Access Compliance Report Public Rights-of-Way (Curb Ramps)

Main Street: SNAPDRAGON_ST		Cross Street: N_SELLAS_RD		Location:	E
ADA ID: RPAT211101110225	Ramp Type: Type 4 - Parallel	Initial Pass/Fail: Fail	Overall Compliance: No	Severity Score:	15
Codes/Mitigation Info/Possible Solution			Field Measurements/Component Compliance

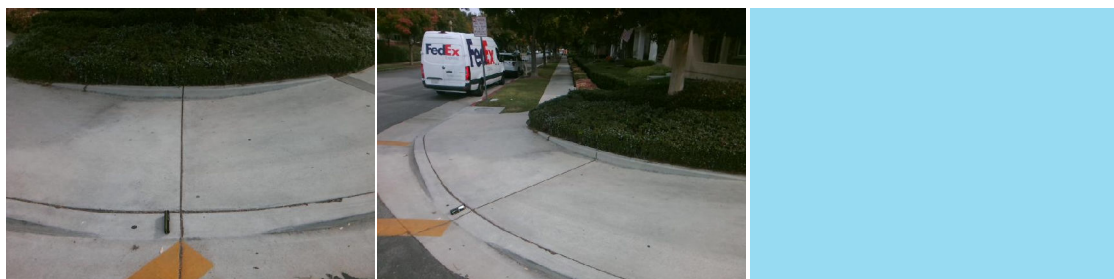
Compliance	Description	Data	Compliance	Description	Data
N/A	Ramp Length LT (in)	95	N/A	Ramp Length RT (in)	79
Yes	Ramp Width LT (in)	89	Yes	Ramp Width RT (in)	89
Yes	Ramp Run Slope LT (%)	0.2	No	Ramp Run Slope RT (%)	8.6
Yes	Ramp Cross Slope LT (%)	1.8	Yes	Ramp Cross Slope RT (%)	1.2
N/A	Landing Present	N/A	N/A	DWS Provided	N/A
N/A	Landing Length (in)	N/A	N/A	DWS Contrast	N/A
N/A	Landing Width (in)	N/A	N/A	DWS Length (in)	N/A
N/A	Landing Run Slope (%)	N/A	N/A	DWS Full Width	N/A
N/A	Landing Cross Slope (%)	N/A		DWS Offset Type	N/A
N/A	Landing Movement Obstructed?	N/A	N/A	DWS Offset Left (in)	N/A
	Landing Movement Type	N/A	N/A	DWS Offset Right (in)	N/A
N/A	Landing Shared	N/A			
N/A	Clear Space	Yes			
N/A	Clear Space To Crosswalk (in)	N/A			
N/A	Marked Crosswalk 1	Yes	N/A	Marked Crosswalk 2	No
	Crossing 1 Direction	NW		Crossing 2 Direction	SW
	Marked Crosswalk 1 Width (in)	120		Marked Crosswalk 2 Width (in)	N/A

Remove & Replace Curb Ramp With Two New Directional Ramps or Equivalent.

R204.3, R304.3.2, STD 1115
